WMJ2 - Rework on Threaded Joint for Ground Point (Workshop Campaign)

Model Line: **911 (992)**

Model Year: **As of 2020 up to 2022**

Concerns: **Threaded joint securing ground point to body**

Checking ground strap and replacing if necessary, reworking screw connection ground point

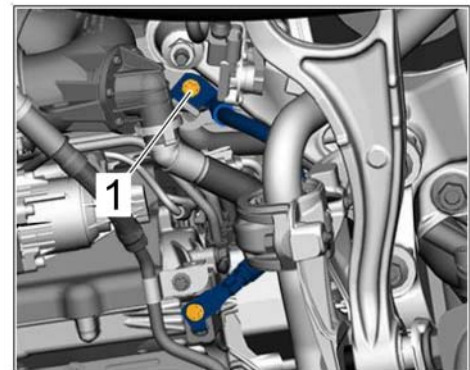
Work Procedure: 1 Unscrew fastening screw ⇒ *Fastening screw for ground strap -1-* on the ground strap.

- 2 Check the contact surface of the ground strap for corrosion and damage. ⇒ *Fault type – ground strap and ground screws*

Assessment		Action
(✓)	Contact surface on ground strap is OK .	Brush off contact surface of the ground strap or clean with sandpaper. Install new fastening screw ⇒ <i>Fastening screw for ground strap -1-</i> and tighten Tightening torque 23 Nm (17 ftlb.) . ⇒ <i>Workshop Manual '978719 Removing and installing ground strap for engine'</i>
(x)	Contact surface on ground strap is not OK	Install new ground strap , Part No. V04015001EH with the new fastening screw ⇒ <i>Fastening screw for ground strap -1-</i> . Check that the tightening torque is correct. Tightening torque 23 Nm (17 ftlb.) ⇒ <i>Workshop Manual '978719 Removing and installing ground strap for engine'</i>
